UNITED STATES PATENT AND TRADEMARK OFFICE

| APPLICATION NO. | FILING DATE | FIRST NAMED INVENTOR | ATTORNEY DOCKET NO. | CONFIRMATION NO. |
|-----------------|-------------|----------------------|---------------------|------------------|
| 10/060,300 | 02/01/2002 | Takao Murakami | 06753.0495 | 7085 |

Office Action Summary

DETAILED ACTION

*Regarding
1-5, 10
Claims*

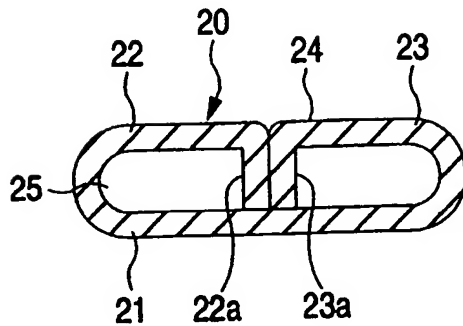
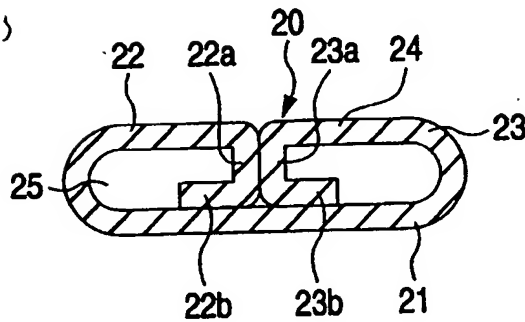
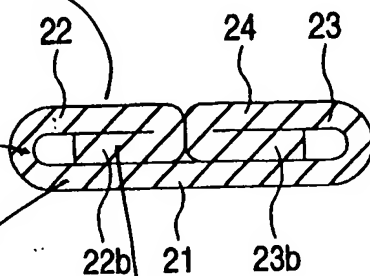
Per claim 2, said overlapping fold plate component includes a side plate element (see attachment) upwardly extending from one side of said base plate component in a plane substantially perpendicular to said base plate component, and a top plate element extending from said side plate element in a plane substantially parallel to said base plate component; and wherein said flatness securing plate component overlaps said base plate component and said top plate element.

Regarding Fukuda, applicant argues that the base is not longitudinally extending from the clamping portion. The examiner disagrees. The base does extend from the clamping portion and the examiner does not agree with applicant's assertion that the identified base is only axially attached (see attachment). It is clear from the drawings that the "base" is continuous longitudinally with the clamping portion.

Right Side

Left Side

Continuous

Cut in this embodiment only

Base Plate

*Side
Plate
Element*

*Overlapping
Fold*

*Flatness securing
plate*
